SERVICE BULLETIN

SB1204

COACH/BUS MODEL : T2145

SUBJECT : Cooling fan tie rod bracket

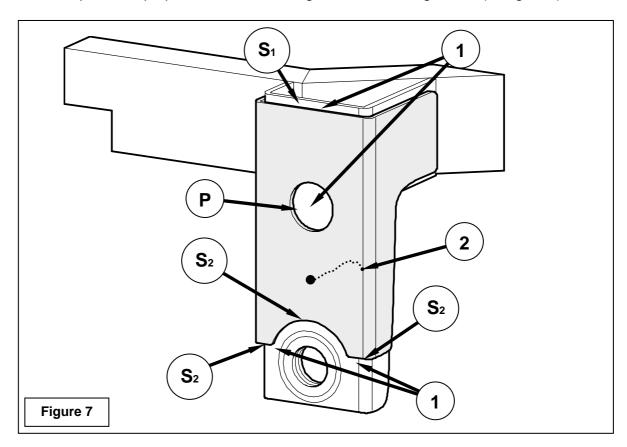
2) A tie rod assembly connects the cooling fan frame to a bracket that has been welded to the coach frame (1, Figure 6).

3) Undo and remove the tie rod outer nuts, top hat washers and rubber bushes (2, Figure 6), both at the cooling fan and at the chassis.

Back up the inner nuts and washers (3, Figure 6).

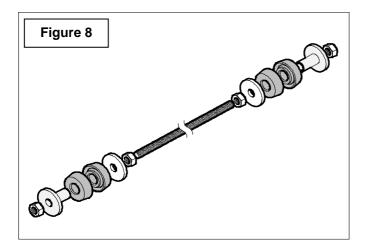
Grind the exterior of the bracket to bare metal along the upper and lower edges and in the center to provide a proper surface for welding on the reinforcing sleeve (1, Figure 7).

2) Using a suitable drill bit, drill a 5/32-inch diameter hole at the end of the crack to stop it from progressing any further.

With a 3" cutter, cut through the notch and the crack (2, Figure 7).

4) Weld the notch and crack (2, Figure 7).Allow the weld to cool.Dress the weld with a grinder.

- 5) Place the reinforcing sleeve over the bracket as shown in Figure 7. Secure with Vise Grip pliers.
- 6) Tack weld the sleeve in place. Remove the Vise Grip pliers.

- 7) Plug weld the hole in the center of the sleeve (see arrow marked 'P').
- 8) Seam weld the sleeve upper edges (S1, Figure 7).
- 9) Stitch weld in the locations indicated by the arrows marked 'S2' in Figure 7.
- 10) Remove all welding equipment and barriers.
- 11) Cover the sleeve and the tie rod bracket with a coat of black chassis paint. Allow bracket and reinforcing sleeve to cool.
- 12) Referring to Figure 8, reassemble and reinstall the tie rod assembly. Adjust tie rod length with the inner nuts. Tighten the tie rod outer nuts with one wrench to a torque of 30 ft.lbf (40 Nm) while holding the inner nuts with a second wrench.
